CITY OF ALBUQUERQUE

RE: EL RANCHO GRANDE, UNIT 8A (M-09/D019B)
Engineers Certification for Release of Financial Guaranty
Engineers Stamp dated 08/06/2003
Engineers Certification dated 09/20/2004

**Re: El Rancho Grande, Units 6,7 & 8 Drainage Report
Engineer's Stamp dated 7-6-01, (M9/D19B)**

DRAINAGE REPORT
FOR
EL RANCHO GRANDE
UNITS SIX, SEVEN, & EIGHT
A 349 LOT SINGLE FAMILY
RESIDENTIAL SUBDIVISION
ALBUQUERQUE, NEW MEXICO
AUGUST 2001

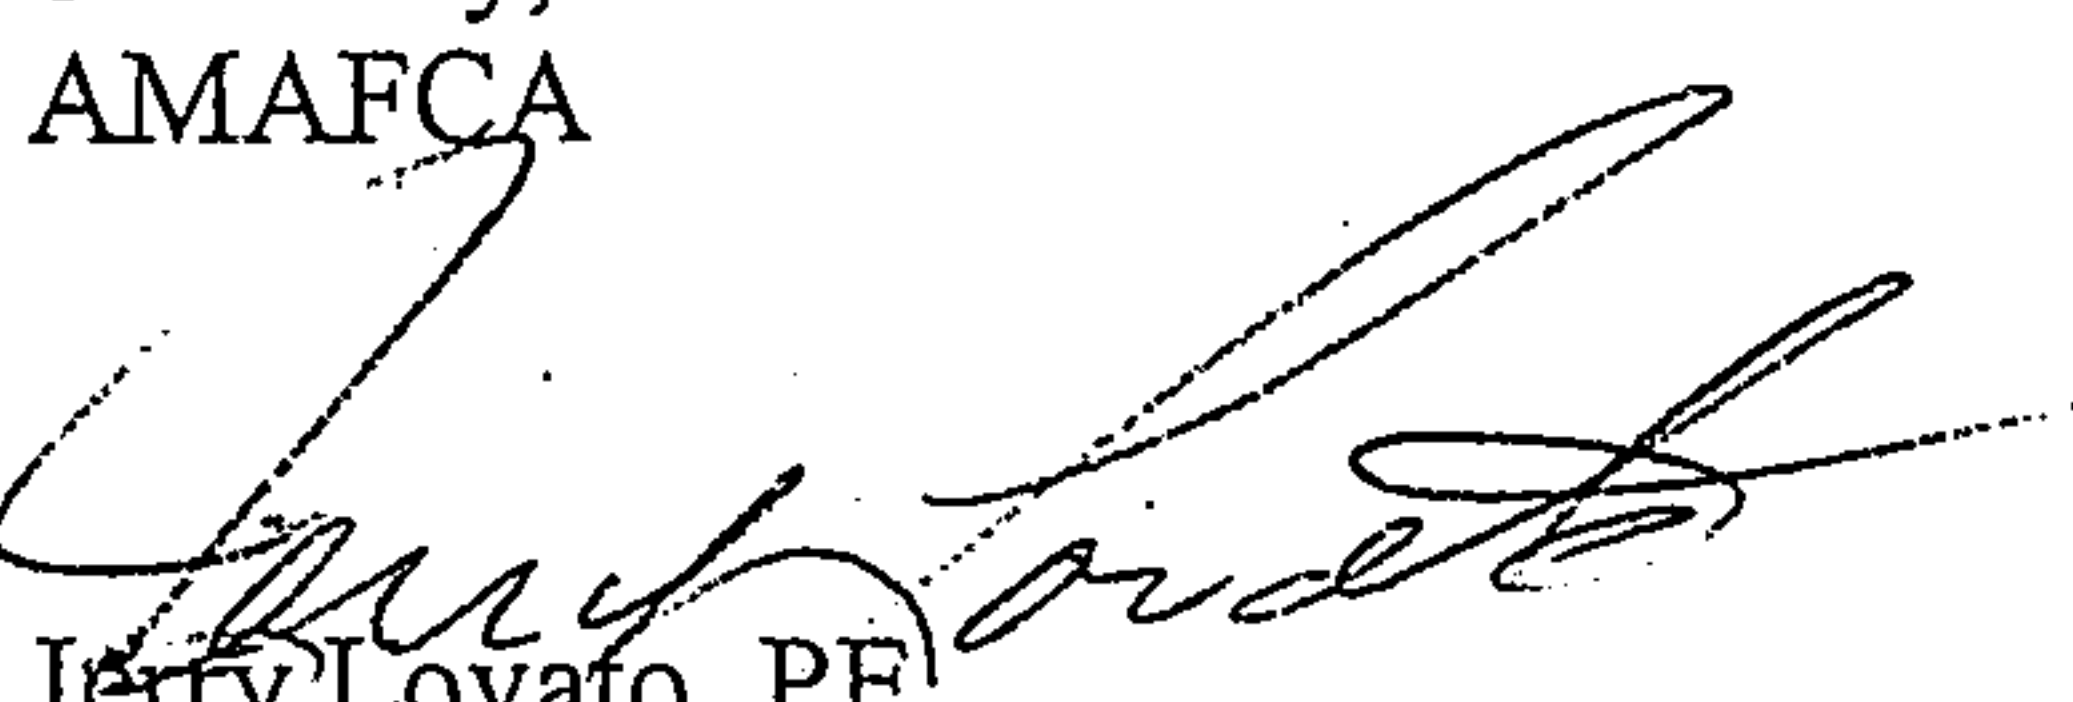
AMAFCA made a field visit to the above referenced project on December 28, 2004. During the site visit the following items were observed.

1. Rundown at the east end of De Anza Drive has been undermined and destroyed.
 - a. Concrete section undermined
 - b. Riprap section from the concrete section into the Snow Vista channel as been destroyed due to excessive undermining.

The conditions found above are disturbing in that the facility is less than a year old. Reviewing the project file, as-builts have not been forwarded to AMAFCA. It is unknown at this time if the rundown was built per the lines and grades shown on the plans.

Please review the design of the rundown to ensure that design was adequate for the location, soil conditions and flows anticipated.

Please submit to AMAFCA, by January 11, 2005, a letter report detailing the cause of the damage to the rundown, verification that the design of the rundown is adequate and a work plan to remediate the rundown
